KSZ8041

KSZ8041 Silicon Errata and Data Sheet Clarification

Module 2: Pin Strapping failures due to 1.8V core power slow ramp-up

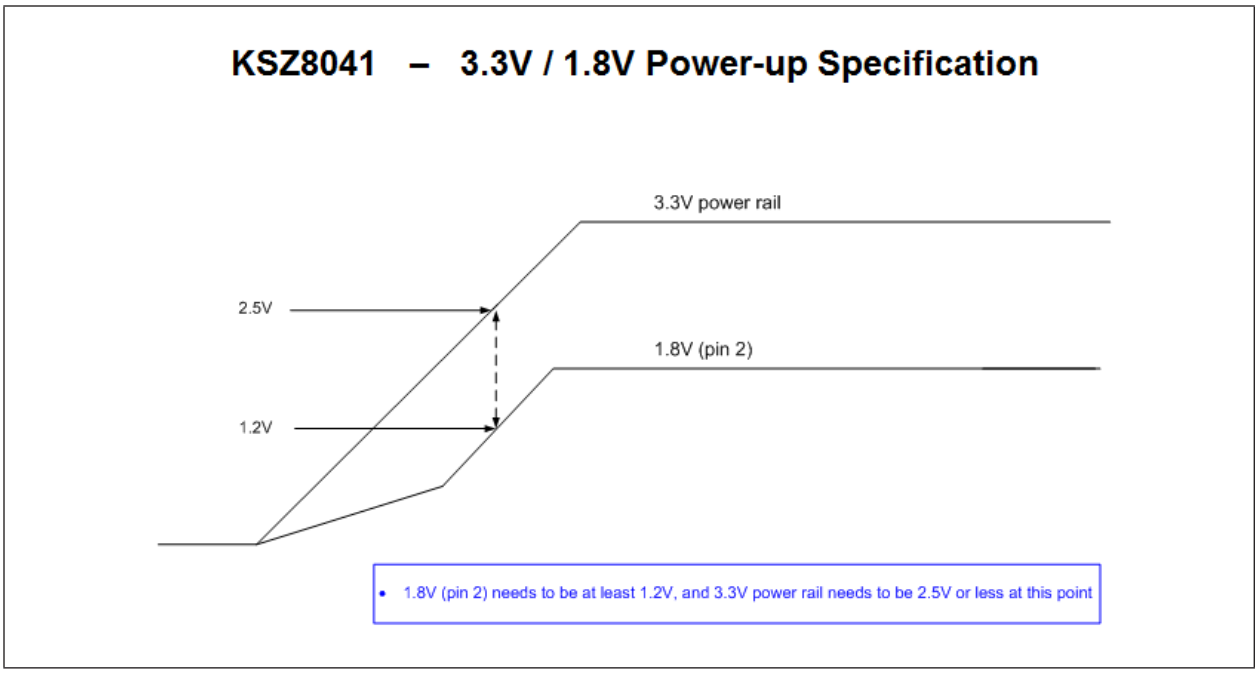
A small percentage (<1%) of devices can potentially encounter pin strapping failures with fast 3.3V supply rise times (<150us) or slow core rail rise times, due to a large bulk storage capacitor value (10uF or greater) for the 1.8V core.

When this errata occurs, pin strap values may not be correctly latched.

Reduce the 1.8V core bulk storage capacitor from 10uF to 1.0uF and ensure the 3.3V supply rise time is 250us or greater.
